State, Federal and Tribal Fishery Agencies Joint Technical Staff

This letter is being provided to you regarding the COE's consideration of operating the McNary Dam turbine units outside of the 1% peak efficiency range.

May 29, 2003

SUBJECT: **Turbine Operations at McNary Dam**

Figure 1. Mean survival and 95% confidence intervals for Kaplan-type turbines operated inside and outside of the 1% of peak efficiency bounds for Columbia/Snake River

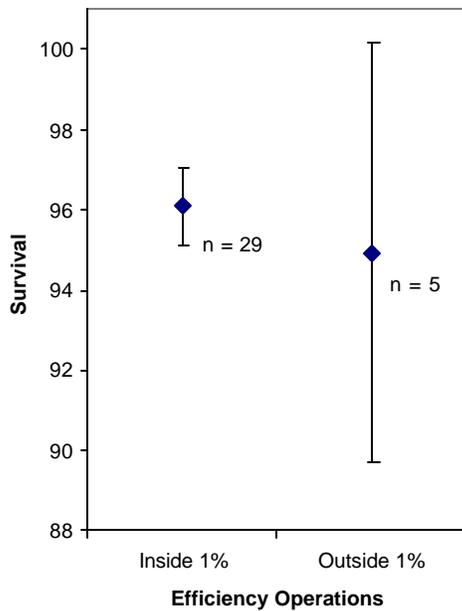
The data evaluated in Skalski et al. (2002) provide a second basis for maintaining the 1% efficiency limits. While their analysis was primarily focused on evaluating the academic question of whether peak survival coincides with peak efficiency, they do provide a useful summary of more recent data on the relevant operational question of maintaining the 1% of peak efficiency limits. Based on the data provided in Skalski et al. (2002, Table A.1), mean survival is reduced by 1.13% (for Columbia/Snake River projects) to 1.64% (for all projects) when Kaplan-type turbines are operated beyond the 1% of peak efficiency limits (Figures 1 and 2). In addition, survival decreases linearly as turbines are operated beyond peak efficiency for Columbia/Snake River projects (Figure 3).
